Riley-Purgatory-Bluff Creek Watershed District
Board of Managers Proposed Rules Special meeting/Board Workshop

To: RPBCWD Board of Managers
From: Scott Sobiech, PE, CFM and Joe Waln, PE, CFM
Subject: **DRAFT** SWLRT Preliminary Alignment Review
Date: April 1, 2014
Project: 23270053

RE: Rule comments review

Figure 1

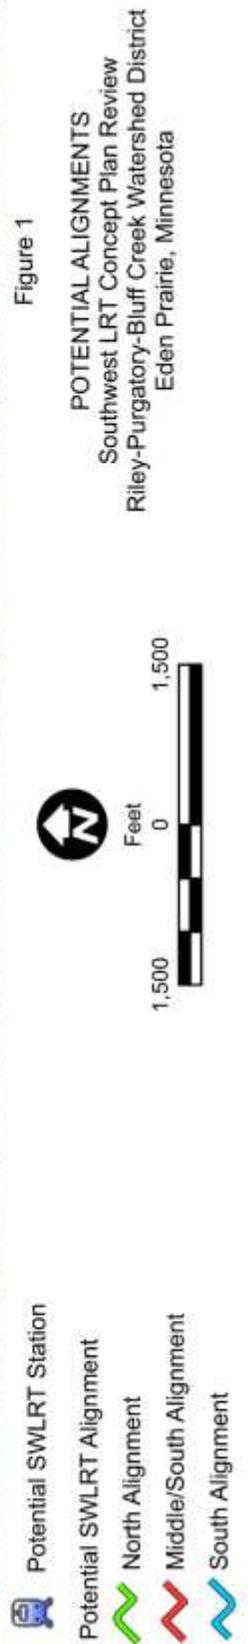
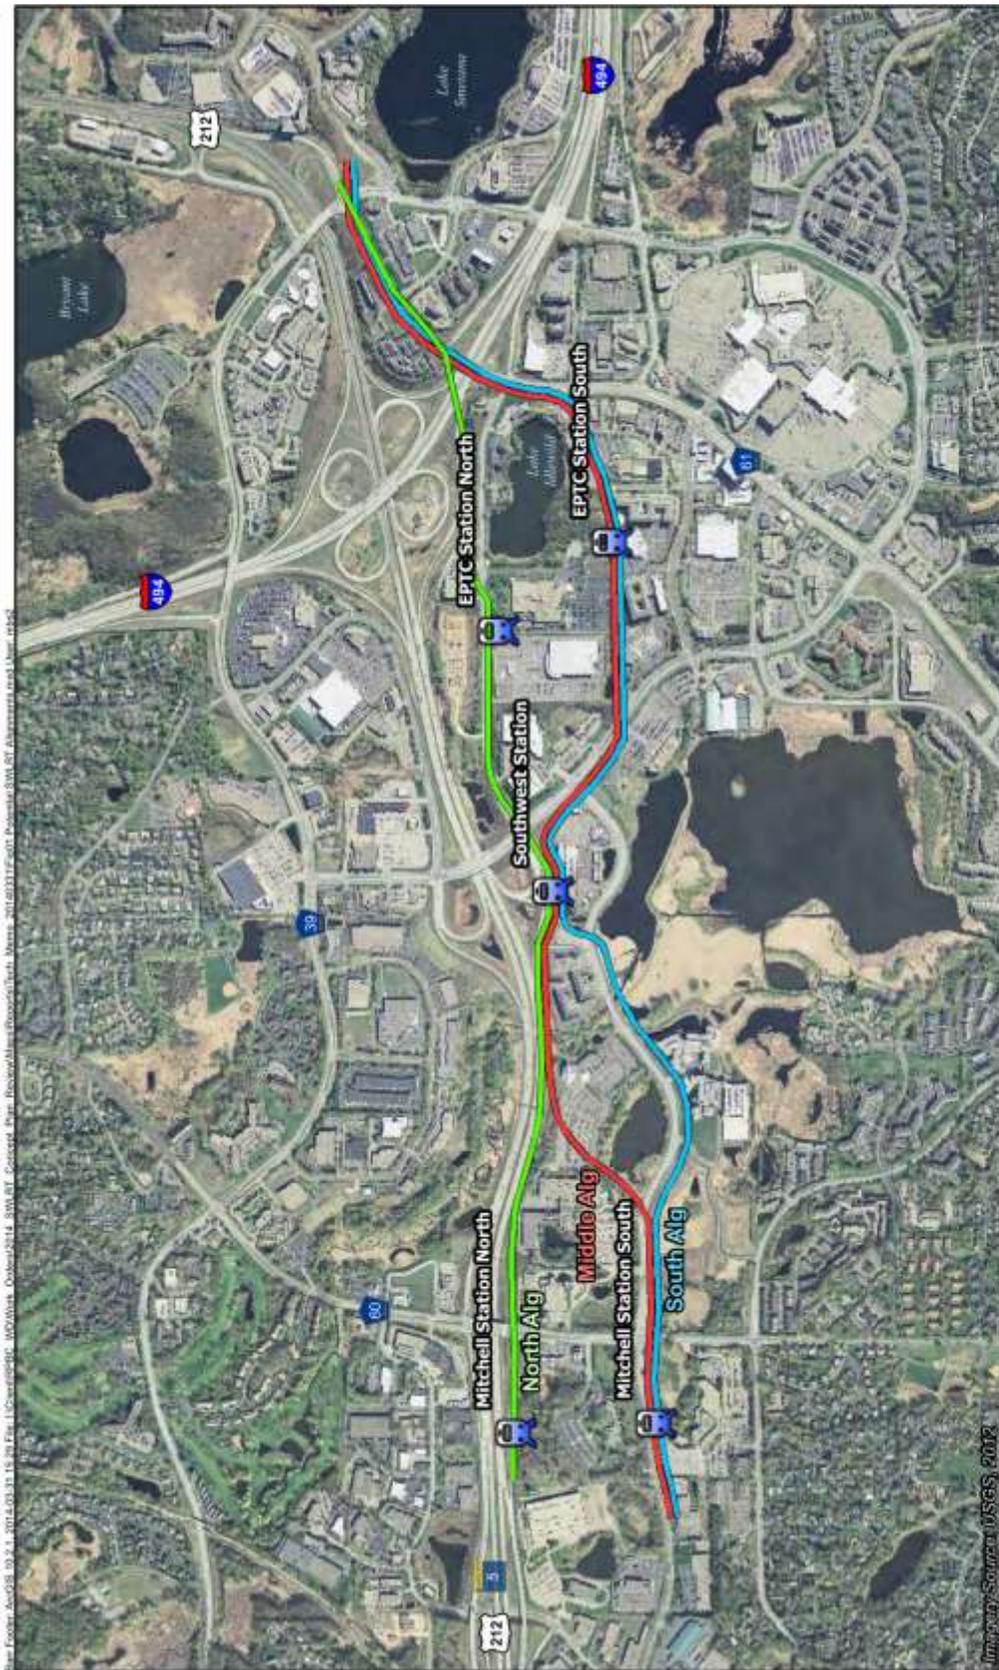
The portion of the proposed SWLRT alignment within RPBCWD is between Prairie Center Drive, east of the US Highway 212 interchange with Interstate 494, and Mitchell Road. As seen in figure 1 below, there are several permutations of the alignment segments, but this review focus is primarily on three scenarios.

- 1) North alignment is a combination of EPTC North and Mitchell North. This was the preferred alignment presented in the draft environmental impact statement, fall 2012.
- 2) The South alignment is a combination of EPTC South and Mitchell South, and appears to be the alignment Met Council will move forward to final design.
- 3) The Middle alignment is similar to the south alignment, except the route between Southwest station and Mitchell station avoids impacts to the Purgatory Creek recreational area by initially following the Mitchell North alignment and then cutting south through the MTS property. This alignment was identified and suggested to the SWLRT by RPBCWD in mid-January 2014.
